CITY OF ALBUQUERQUE

**RE: Lot 5 Block 4 Volcano Cliffs SAD 228
6412 Papagayo Rd. NW
Grading and Drainage Plan
Engineers Stamp Date: 11/7/2022 (D10D003D5, HYDR-2025-00409)
CO Certification Date: 11/17/2025**

ENGINEER'S SEAL	LOT 5 BLK 4 U 22 VC 6412 PAPAGAYO ROAD	DRAWN BY DEM
DAVID SOULE P.E. #14522		DATE 11-4-22
	GRADING AND DRAINAGE PLAN	6412 Papagayo Rd.DWG
	Rio Grande Engineering	SHEET # C1
	P.O. BOX 53324 ALBUQUERQUE, NM 87199 (505) 321-8099	JOB #

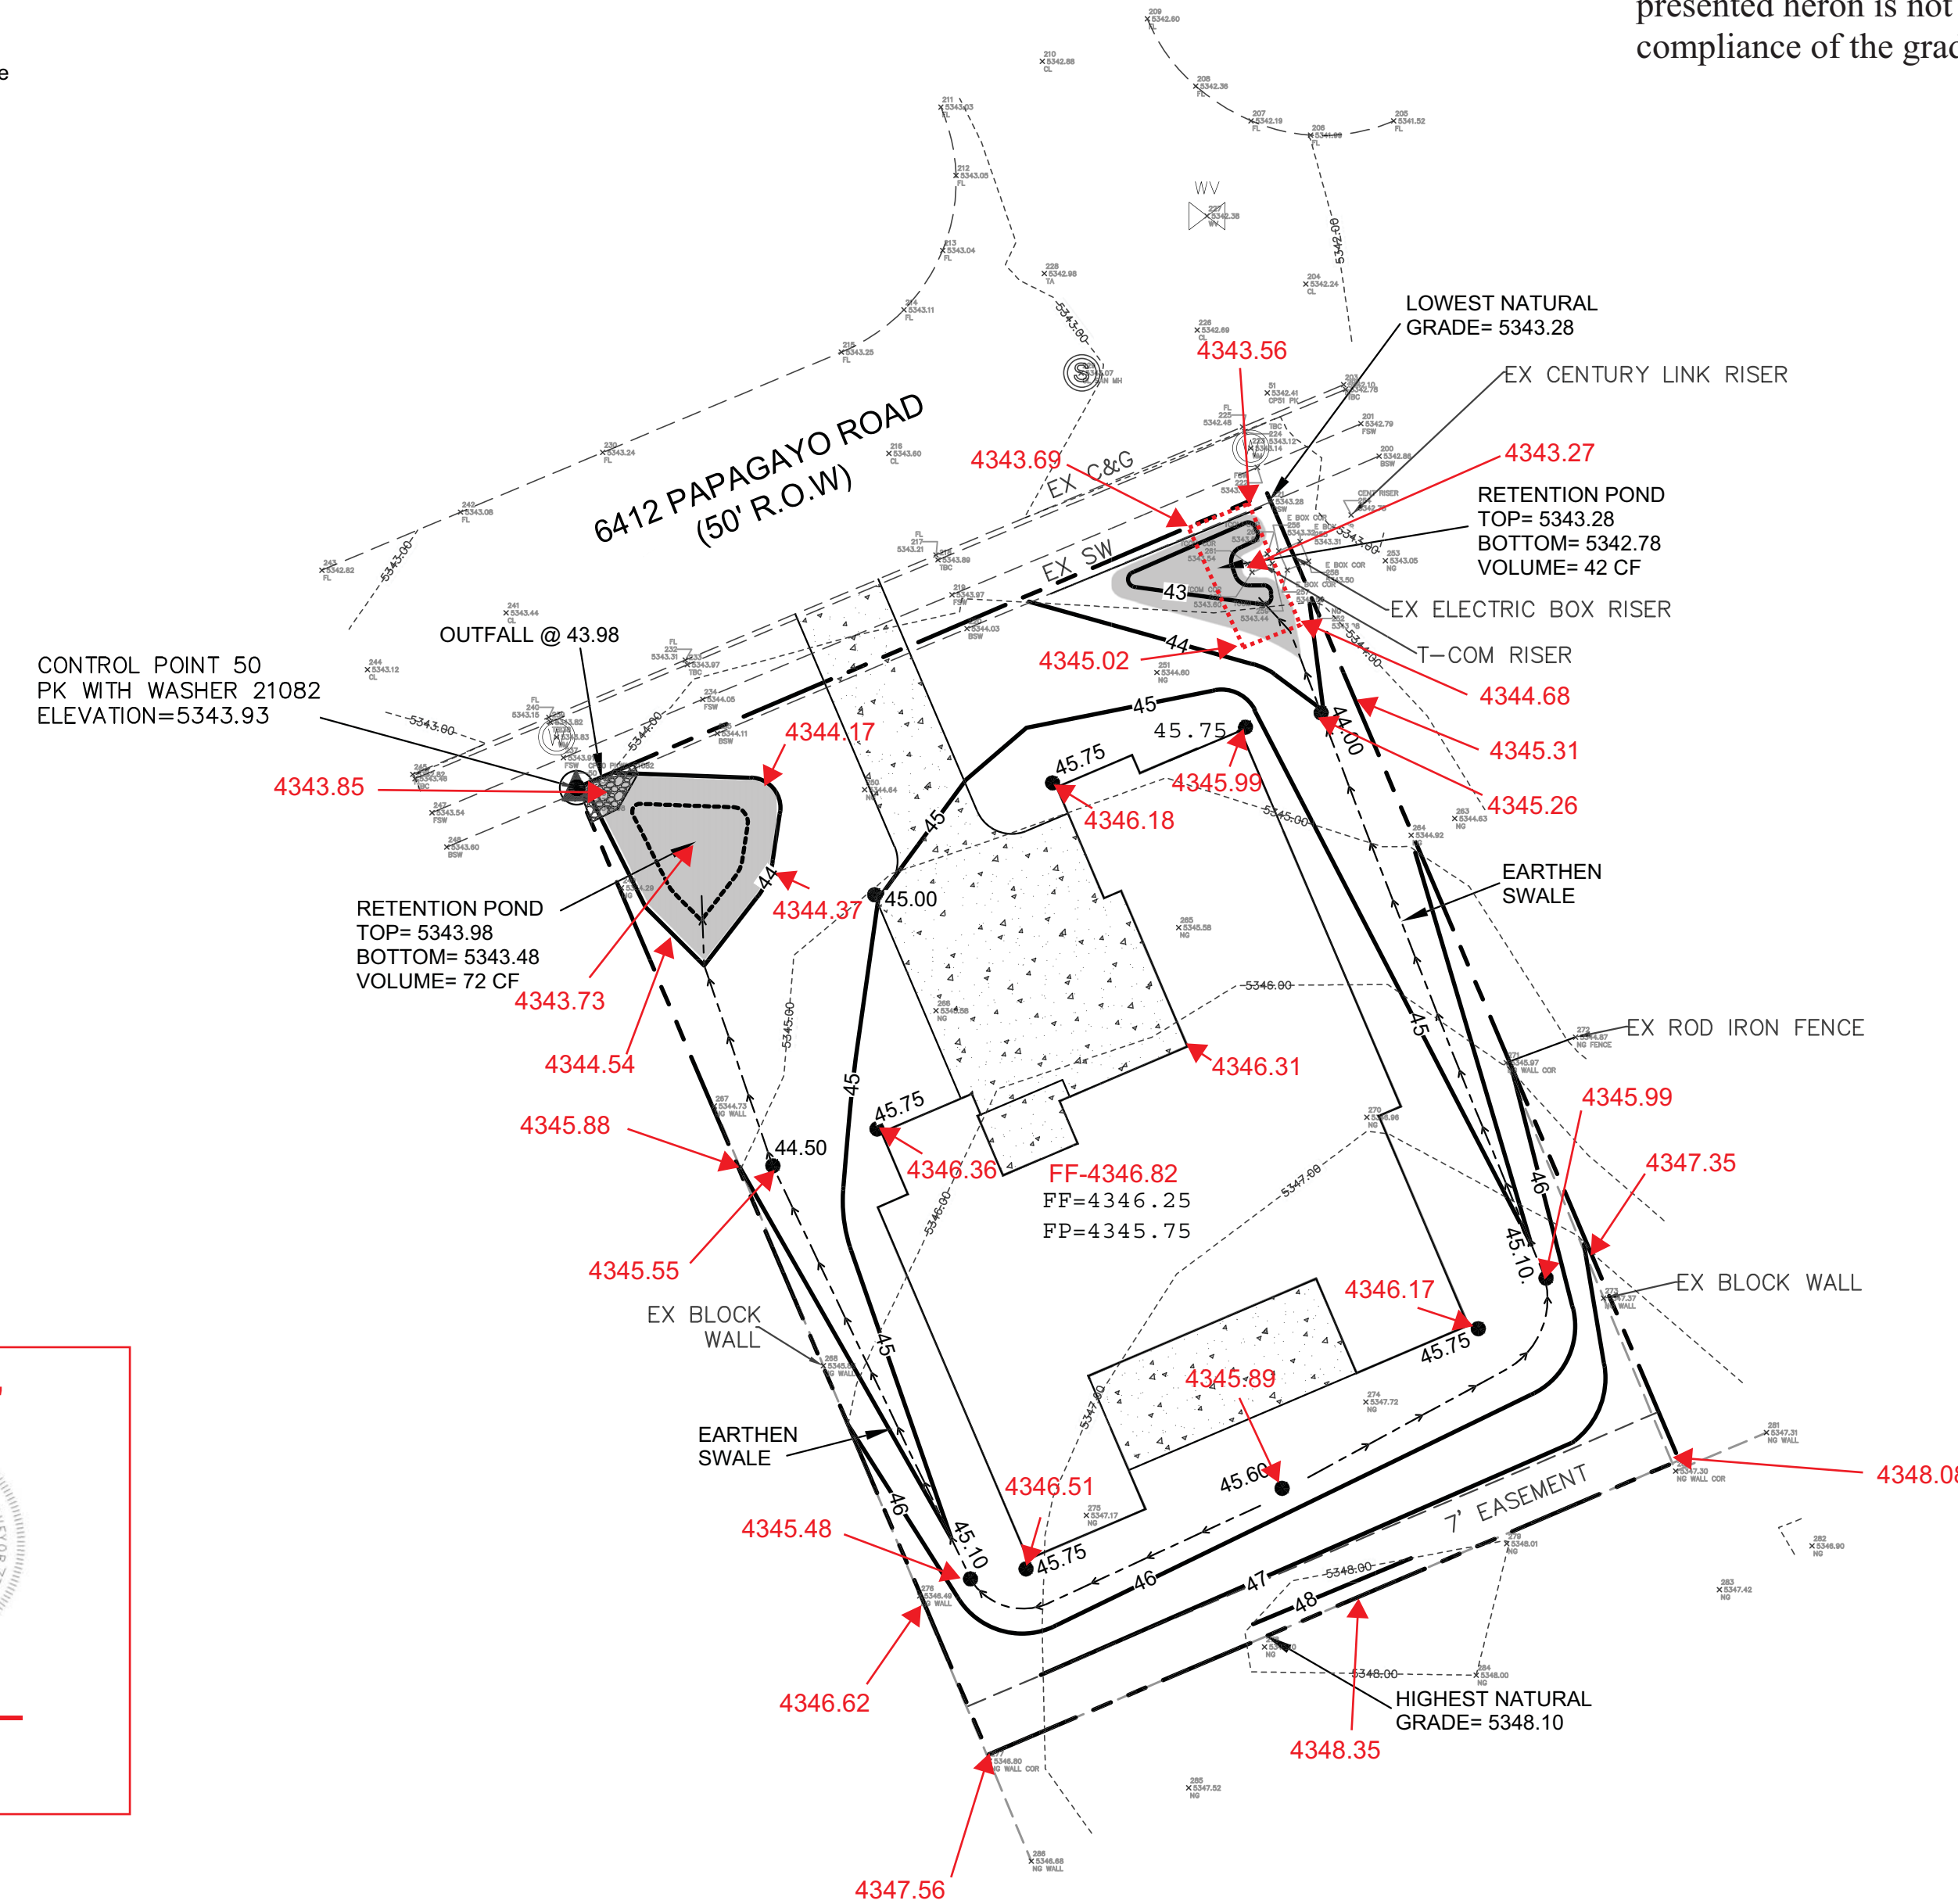
- North side of property drains into neighbors' yard, this needs to be remedied.
- Erosion control needs to be placed all around the home due to the slope around the home.
- Some areas need to be graded much better.
